Re: Turkey Point Units 3 and 4
Docket Nos. 50-250 and 50-251
Response to Request for Additional Information for the
Review of the Turkey Point Units 3 and 4
License Renewal Application

**ATTACHMENT 1
RESPONSE TO REQUEST FOR ADDITIONAL INFORMATION
DATED JANUARY 31, 2001 FOR THE REVIEW OF THE
TURKEY POINT UNITS 3 AND 4,
LICENSE RENEWAL APPLICATION
ENVIRONMENTAL REPORT
SEVERE ACCIDENT MITIGATION ALTERNATIVES**

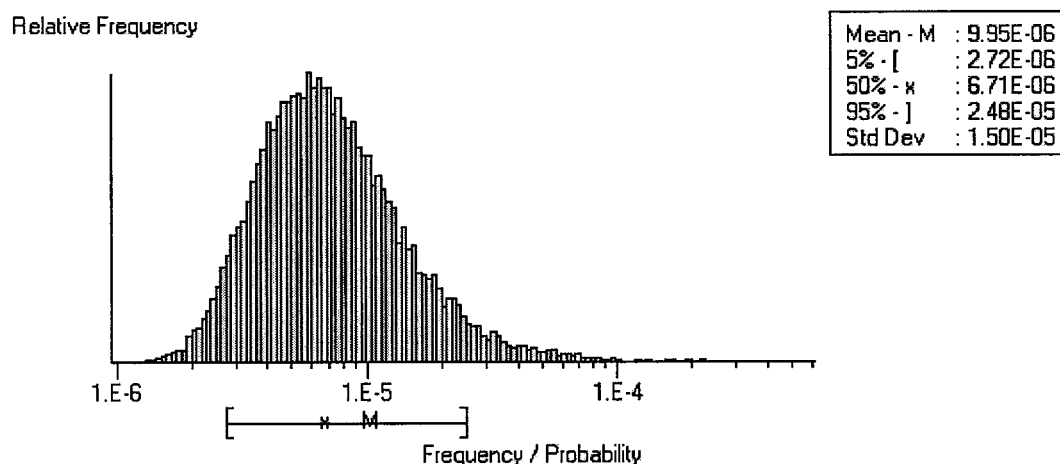
Please provide the uncertainty range associated with the internal events CDF for the base-case PRA. Please show the impact of considering the uncertainties in the estimated CDF on the current SAMA cost-benefit conclusions. If the uncertainties in estimated CDF are not available, please determine the qualitative risk impact by considering the impact of uncertainty ranges as reported in typical level-1 PRA (e.g., NUREG-1150), on the estimated risk results.

In 2000, an update of the Turkey Point PSA was performed. A plot of the uncertainty distribution of the latest internal events CDF is shown below.

The 95th percentile associated with this distribution is 2.48E-05/Yr. The SAMA baseline CDF of 1.62E-05/Yr corresponds to the 88th percentile of the latest CDF distribution. Other factors that offset the higher CDF associated with higher failure rates include modeling uncertainties and cost estimates.
